CITY OF
West Linn
 PLANNING AND DEVELOPMENT

**STAFF REPORT
 PLANNING MANAGER DECISION**

DATE: March 6, 2015
 FILE NO.: MIP-14-08
 REQUEST: Request for a 2-lot Partition at 5651 Cascade Street
 PLANNER: Peter Spir, Associate Planner

**SLOPE ANALYSIS AND TREE PROTECTION PLAN
CASCADE PARTITION**

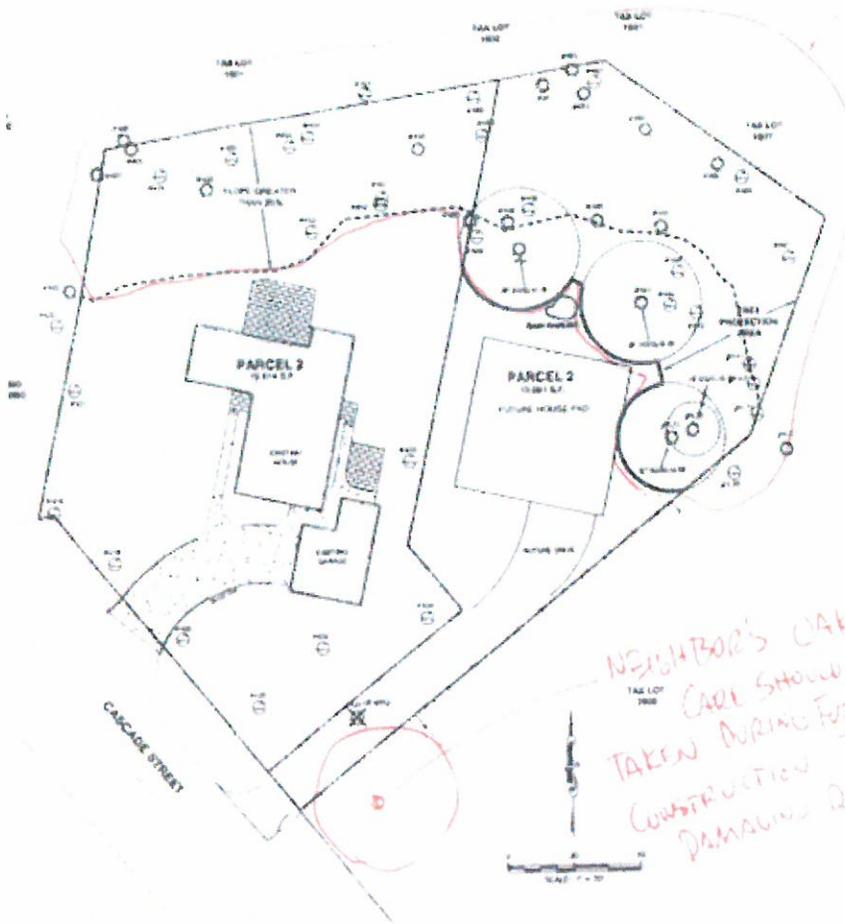
Staff Response 21: There are no heritage trees on this property. The rear of the site comprises a heavily treed hillside. The City Arborist identified the trees on the hillside (Type I and II lands) as significant. (see Arborist's map below). No residential project is proposed in this Type I/II area.

In addition, the City Arborist determined that there are four large Douglas Firs above the top of the slope (non-Type I and II lands) that are significant. (Those trees are identified on the "Slope Analysis and Tree Protection Plan" Sheet 2/3 as 447, 443, 435 and 436.) Pursuant to 55.100(B)(2)(b) above, the applicant has proposed to protect those four Douglas Fir trees. Whereas 55.100(B)(2)(b) seeks to protect up to 20% of the significant trees on non-Type I and II lands, the applicant's proposed tree protection constitutes 100% of the significant trees on the non-type I and II lands at this site. These identified trees on the residential project are subject to the tree conservation easement (condition of approval #3.)

The City Arborist proposed protection of the four Douglas Firs during development would come in the form of cyclone fences around the tree drip lines. These fences would remain in place until completion of development and home construction (see "Notes to Developer/Builder"). After the removal of the fencing, tree protection, provided through the Municipal Code, will apply.

The City Arborist also recommended that protective measures be put in place to help protect the roots of a mature oak tree on the property at 5641 Cascade Street. (See "Notes to Developer/Builder".)

NEIGHBOR'S OAK - CARE SHOULD BE TAKEN DURING FUTURE CONSTRUCTION TO AVOID DAMAGING ROOTS

3. Tree Conservation Easement. The applicant shall provide a tree conservation easement that shall protect the significant trees identified on the non-Type I & II lands on the "Slope Analysis and Tree Protection Plan" Sheet 2/3 as 447, 443, 435 and 436. The easement shall include a legal description and map of the area.
 - a. The easement document shall be reviewed by the City prior to being presented to the City Council for consideration.
 - b. If approved by City Council, the easement shall be recorded with the County and a copy of the recorded easement shall be provided to the City.

Notes to Developer/Builder: The City Arborist provides the following comments for the construction phase: "The developer/builder shall install cyclone fencing, per West Linn Tree Technical Manual, around the drip lines of Douglas Fir trees 447, 443, 435 and 436, (as identified on the "Slope Analysis and Tree Protection Plan" Sheet 2/3) prior to, and through completion of development on parcel 2. A snow fence shall also be installed from the paved portion of Cascade Street northeasterly along the common lot line with the property at 5641 Cascade Street for a distance of 70 feet to protect the neighbor's Oak tree roots to the degree possible. The oak tree's location is identified in the City Arborist's map which is part of the record."
